Access Compliance Report

Public Rights-of-Way

Intersection ID: 42942	Main Street: LONG_PAW_LN	Cross Street: REMICK_CT	Location: NW
ADA ID: EF2D7A1DE480	Ramp Type: PerpDiag	Initial Pass/Fail: Fail	Overall Compliance: No
			Severity Score: 33.75

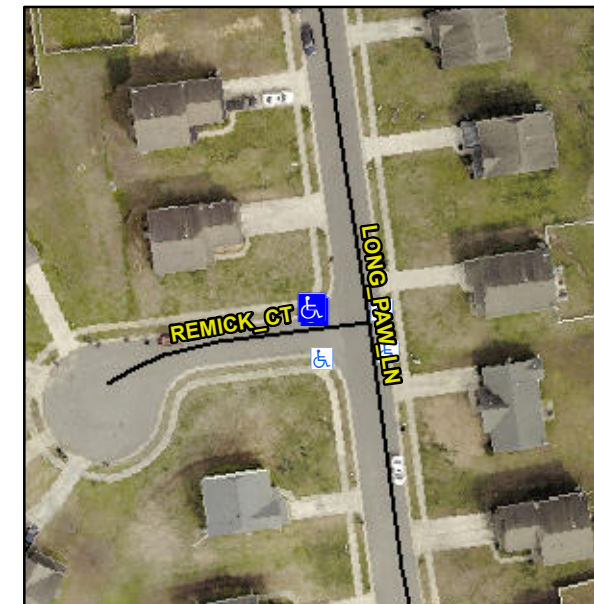
Not Found, R304.5.1, R304.2.2, R304.5.3

Compliance	Description	Data	Compliance	Description	Data
N/A	Ramp Length (in)	48.5	No	Ramp Slope (%)	8.4
No	Ramp Width (in)	39.0	No	Ramp XSlope (%)	5.6
N/A	Flare Type LT	N/A	N/A	Flare Type RT	N/A
N/A	Flare Slope LT (%)	N/A	N/A	Flare Slope RT (%)	N/A
N/A	Flare Traversable LT?	N/A	N/A	Flare Traversable RT?	N/A
N/A	Landing Length (in)	N/A	N/A	DWS Provided?	N/A
N/A	Landing Width (in)	N/A	N/A	DWS Contrast?	N/A
N/A	Landing Slope (%)	N/A	N/A	DWS Length (in)	N/A
N/A	Landing X Slope (%)	N/A	N/A	DWS Full Width?	N/A
N/A	Landing Curb? (Y/N)	N/A	N/A	DWS Offset (in)	N/A
N/A	Shared Landing?	N/A			
N/A	Gutter Ponding?	N/A	N/A	Gutter Slope (%)	N/A
N/A	Gutter Lip Ht (in)	N/A	N/A	Gutter X Slope (%)	N/A
N/A	Painted X Walk1?	No	N/A	Painted X Walk2?	No
	X Walk 1 Direction	To S		X Walk 2 Direction	To E
N/A	X Walk 1 Width (in)	N/A	N/A	X Walk 2 Width (in)	N/A
	X Walk 1 Slope (%)	0.2		X Walk 2 Slope (%)	5.2
	X Walk 1 X Slope (%)	5.6		X Walk 2 X Slope (%)	1.8

Remove & Replace Curb Ramp With Two New Directional Ramps or Equivalent.
